Palladium at Aero Drive

Kearny Mesa Community Plan – Draft Amendment

In response to comments received at the Planning Commission hearing on October 16, 2008, I am writing to share changes made to the Palladium at Aero project. We appreciate the candor of the Planning Commissioners and feel that the changes made respond directly to the issues you raised.

Palladium at Aero has been substantially redesigned in response to the comments that we heard from the Planning Commission and representatives of the adjacent Serra Mesa community at the hearing on October 16. Changes have been made to the project height, site plan and architectural treatments on the east, west and north sides.

REVISED STREETScape GUIDELINES

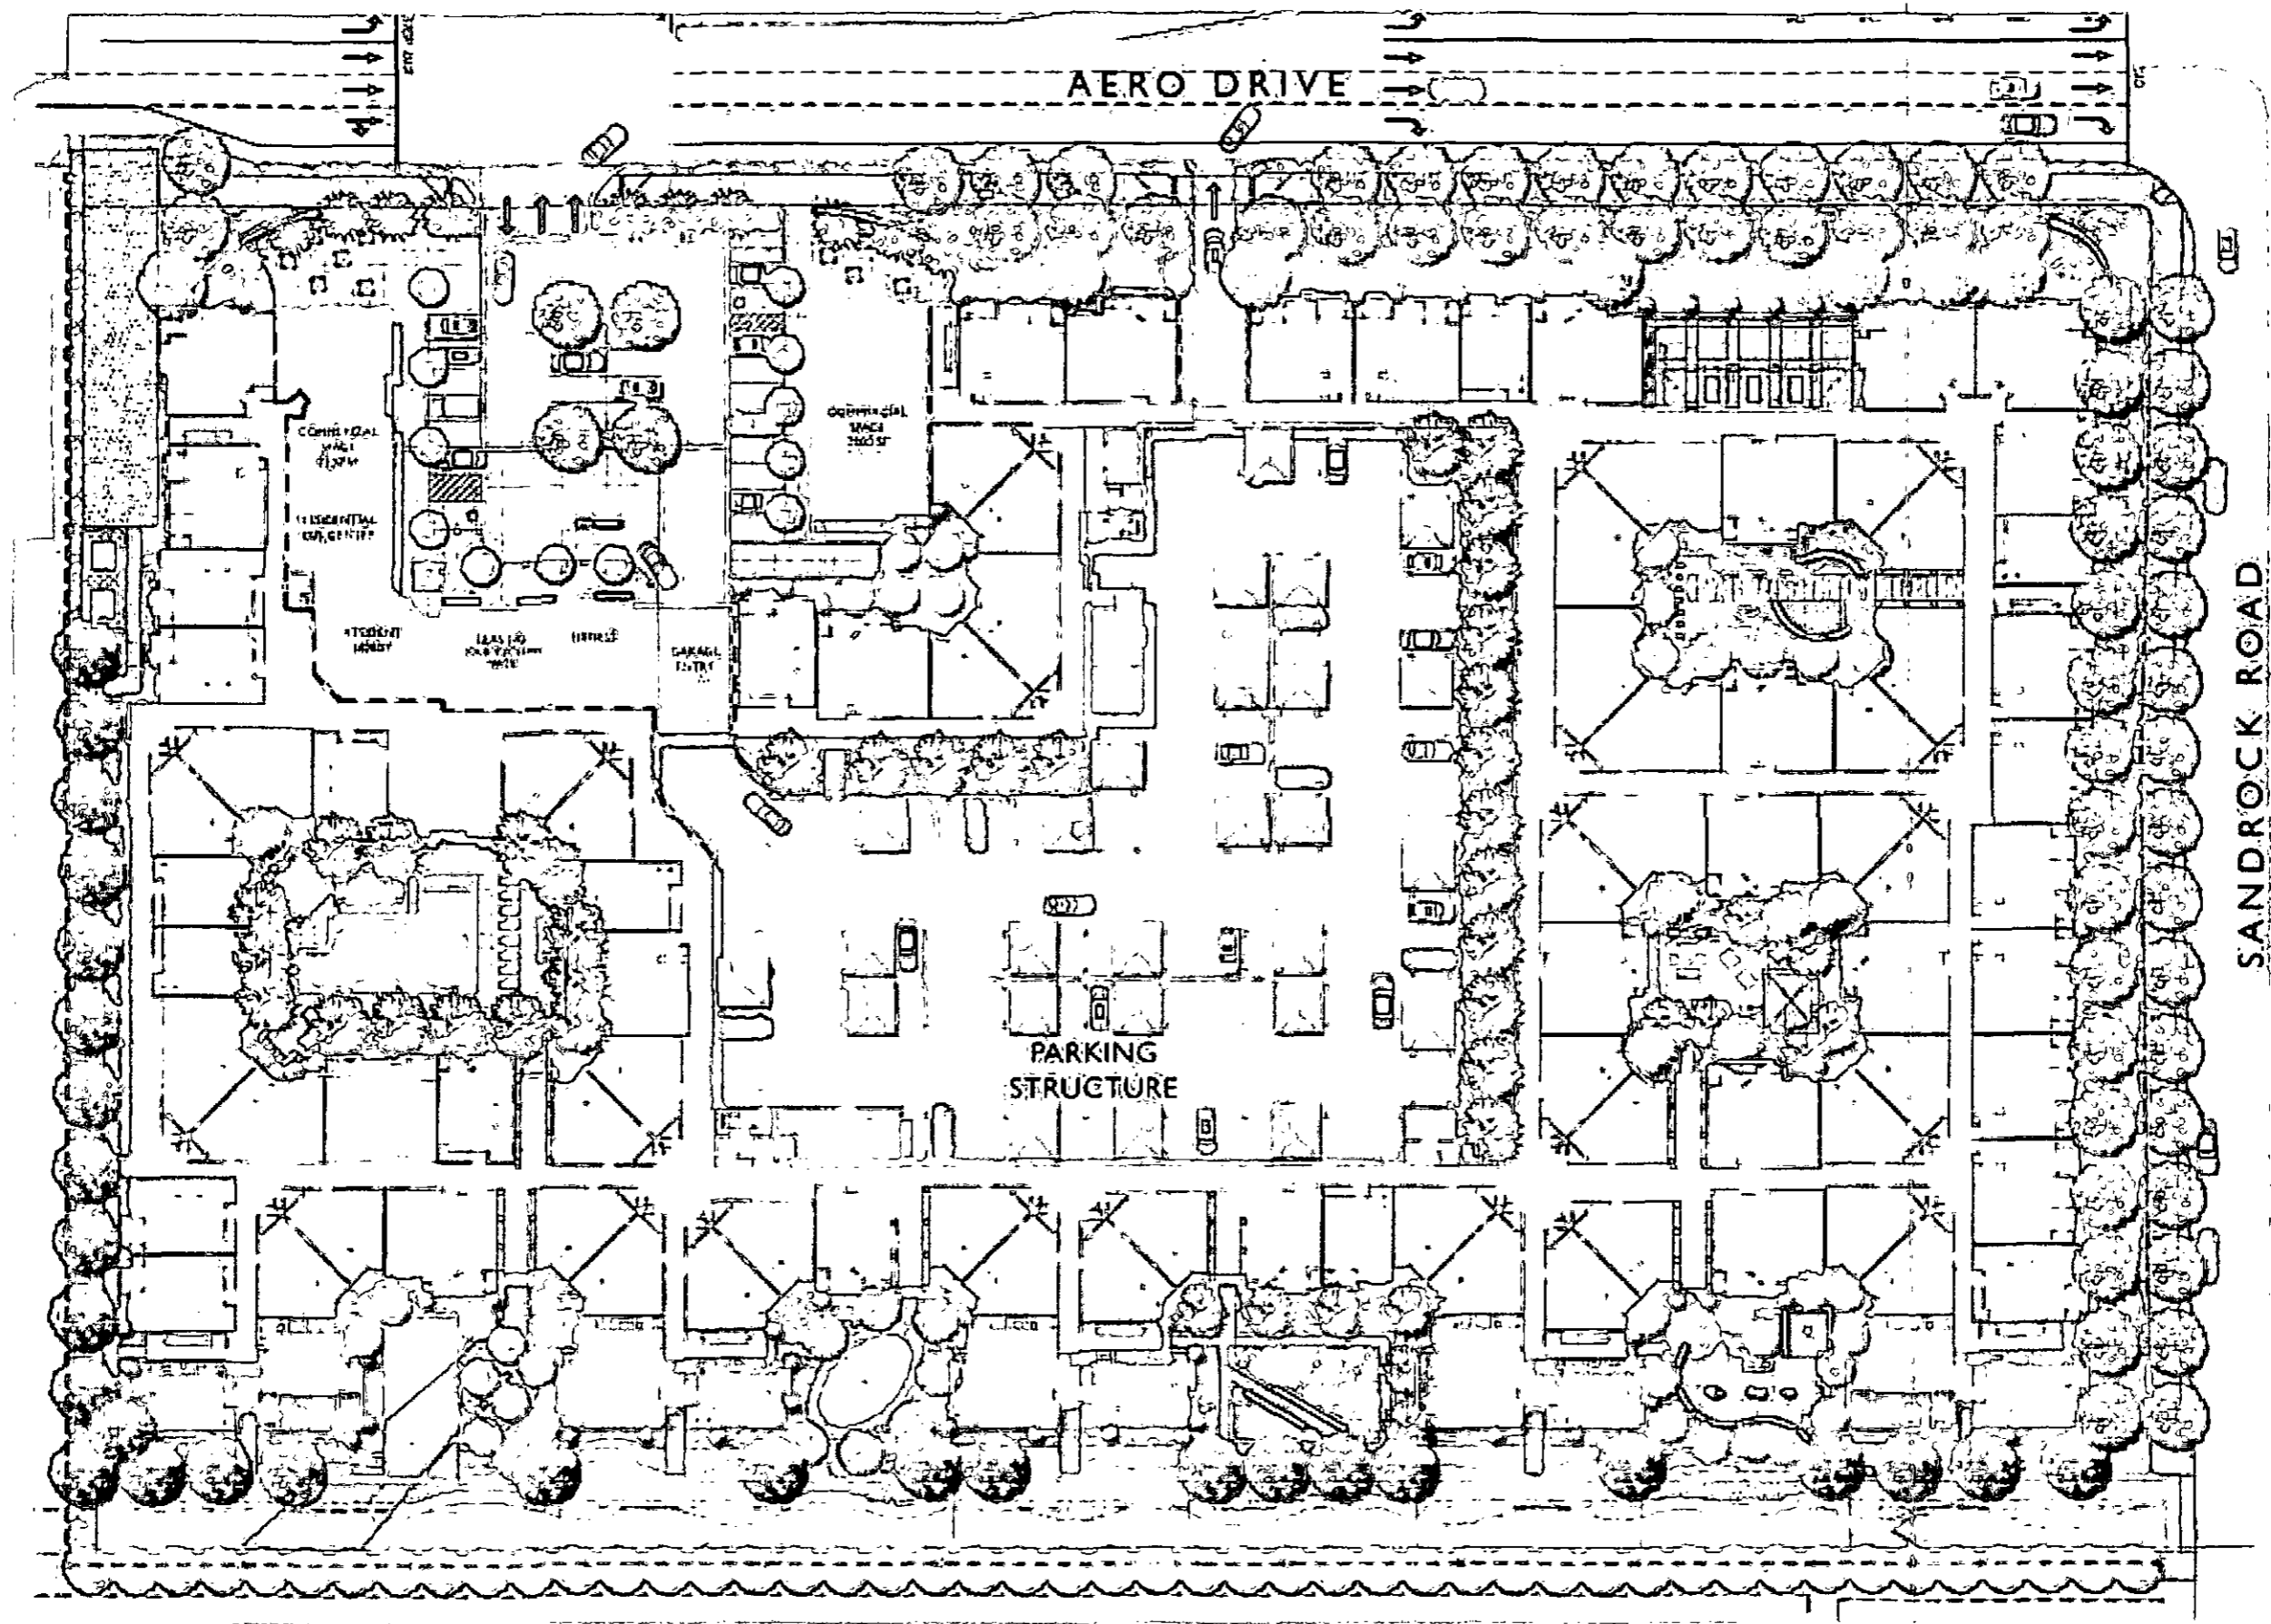
In response to comments made by the Commission and members of the Serra Mesa community, we have made modifications to the streetscape guidelines that staff has asked us to include as part of the Community Plan Amendment (see attached). The following changes have been incorporated:

- The tree grates proposed in the original guidelines have been removed to allow trees to be planted directly in the parkway.
- The parkway plant palette has been modified.
- The gateway plaza at the southeast corner of Kearny Villa Road and Aero Road has been removed in response to comments that it is unlikely that this corner will be available for this use.

- REMOVE TREE GRATES AND REVISE PARKWAY PALETTE

ORIGINAL SITE PLAN

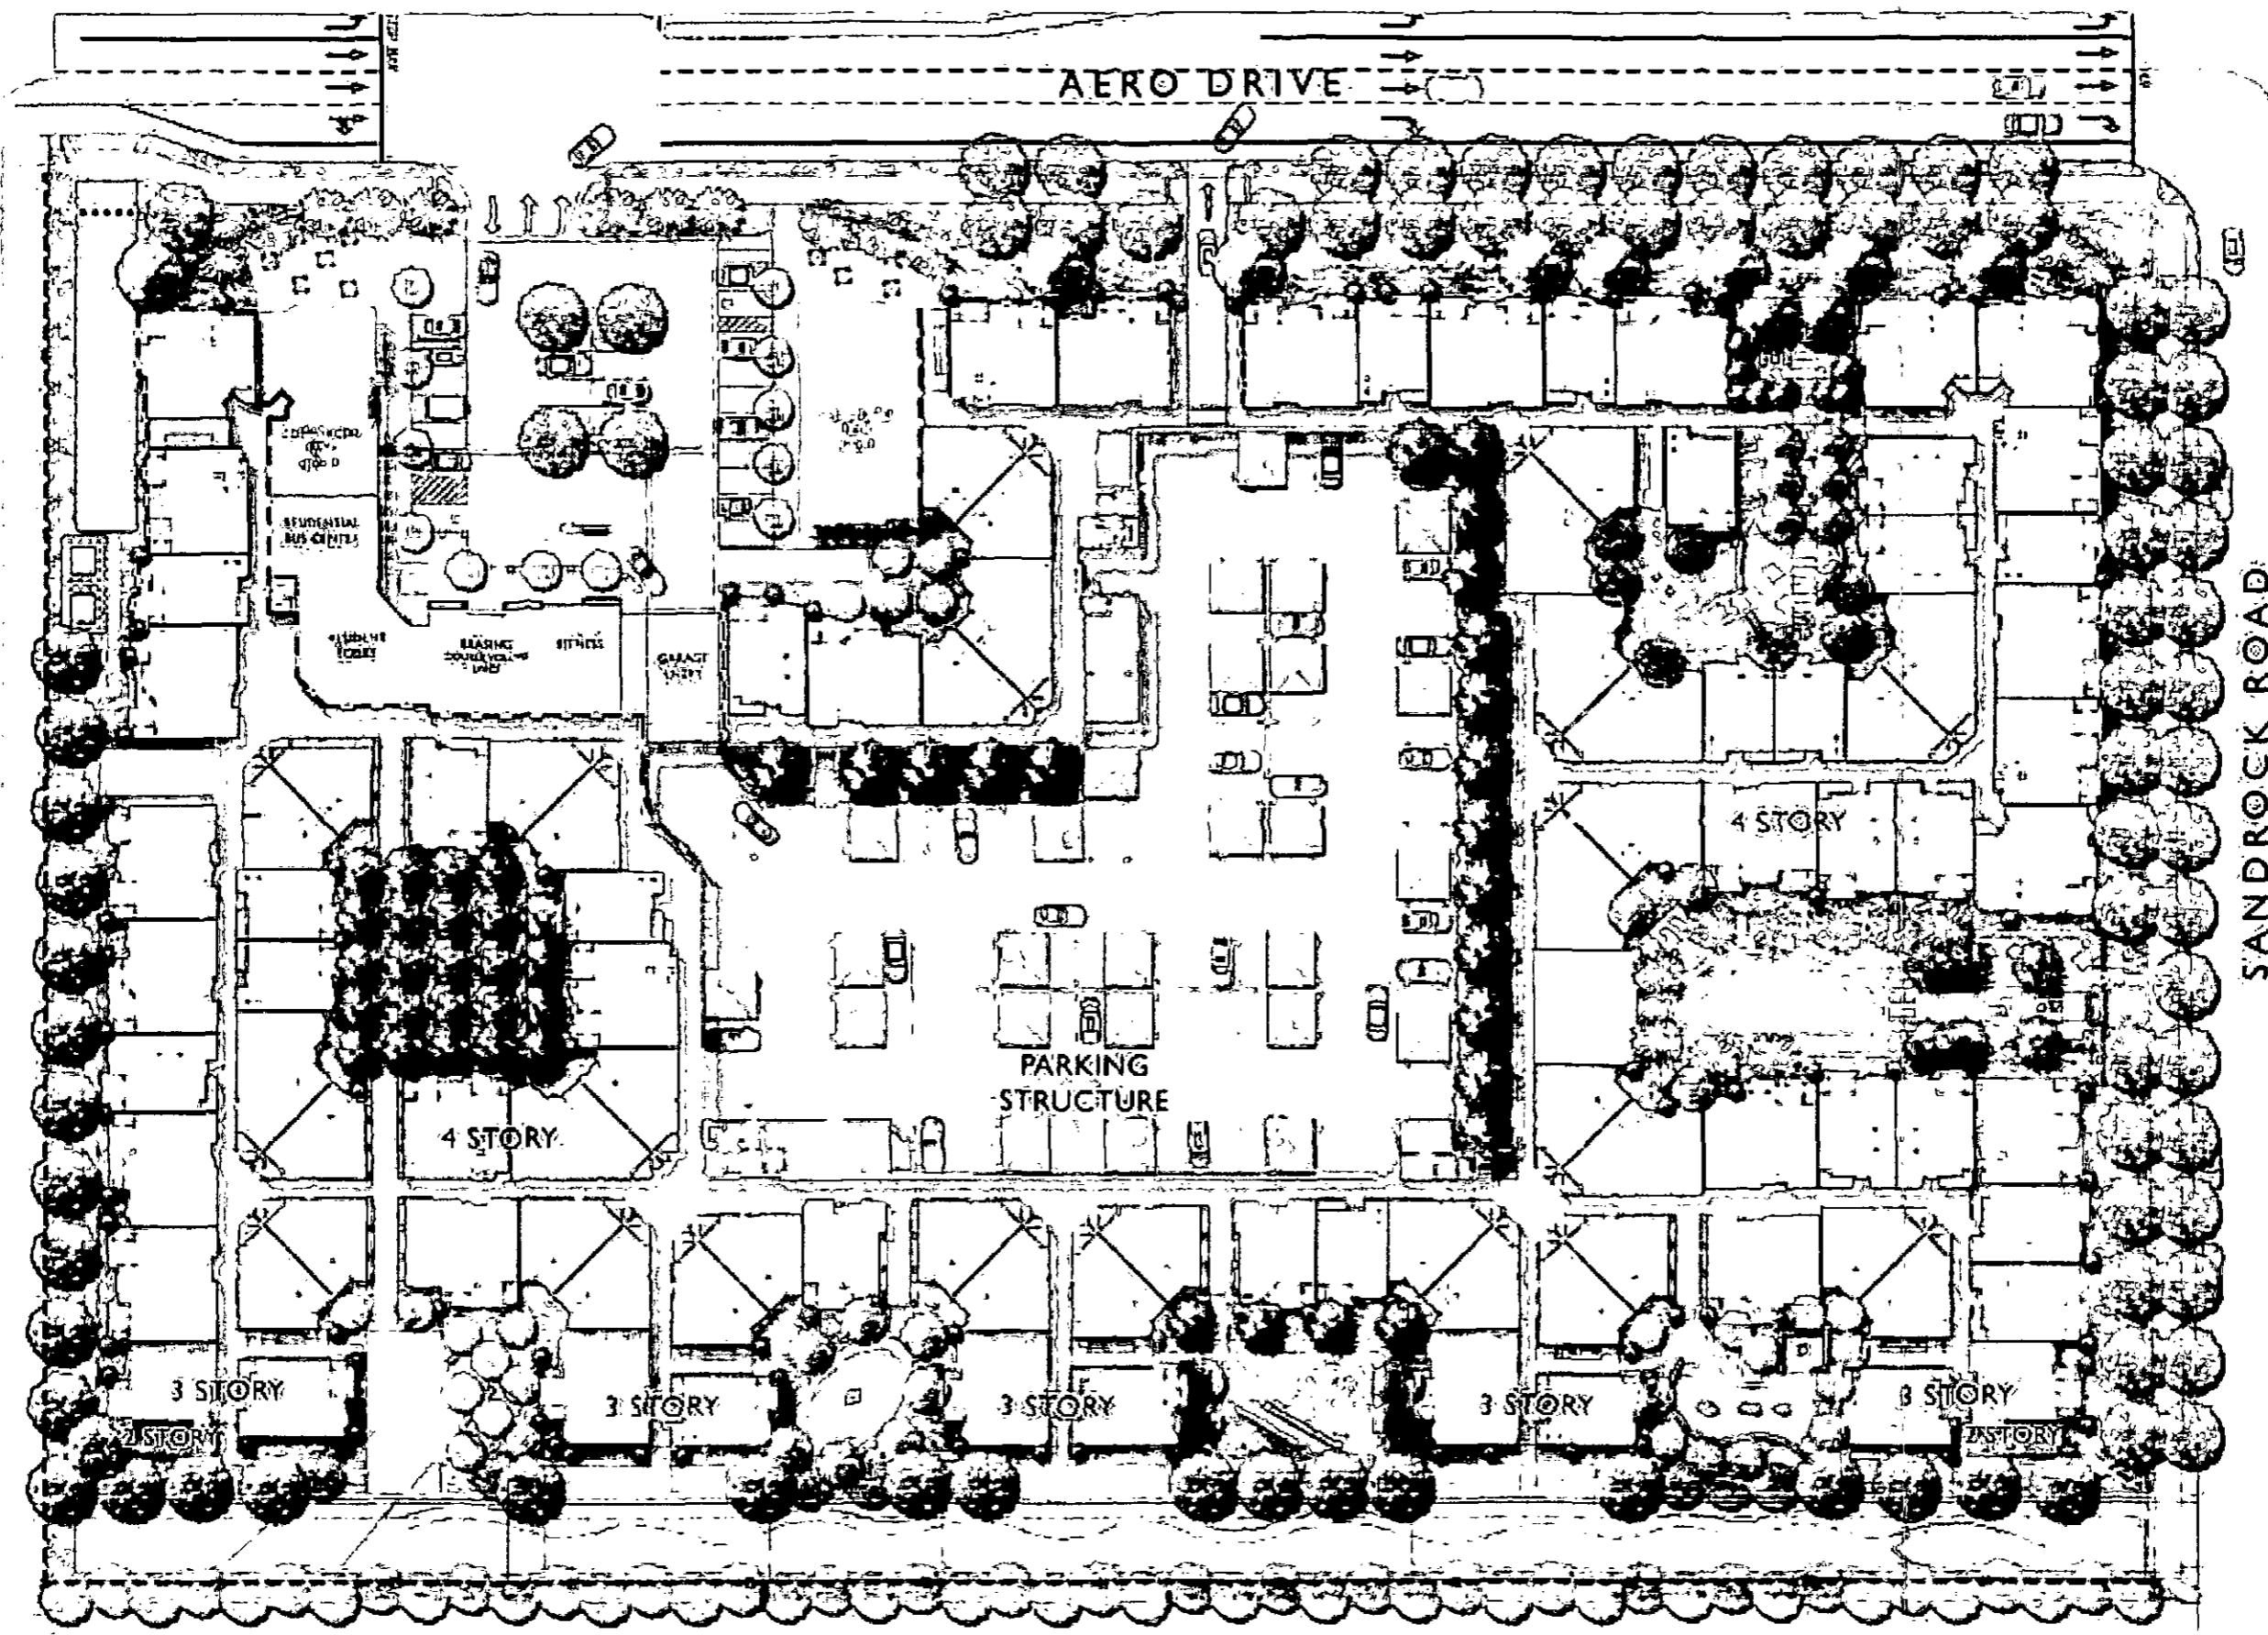
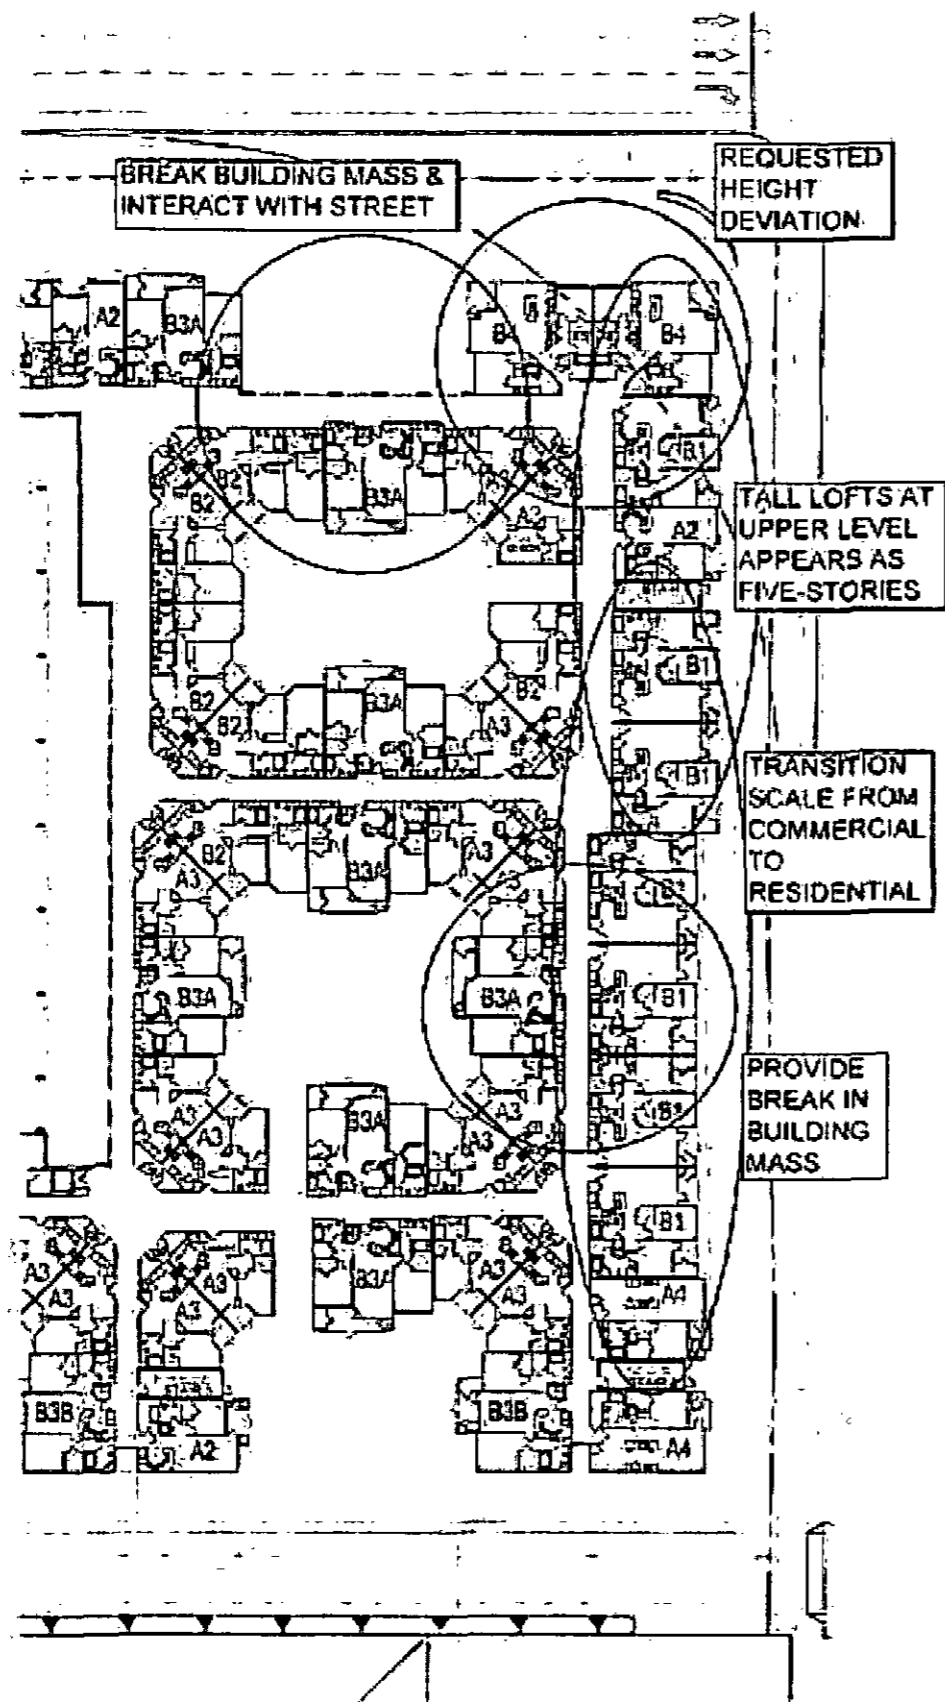
The project's eastern frontage (Sandrock Road) has been revised to acknowledge the transition from urban development to the single family neighborhood to the south.

PROPOSED NEW SITE PLAN
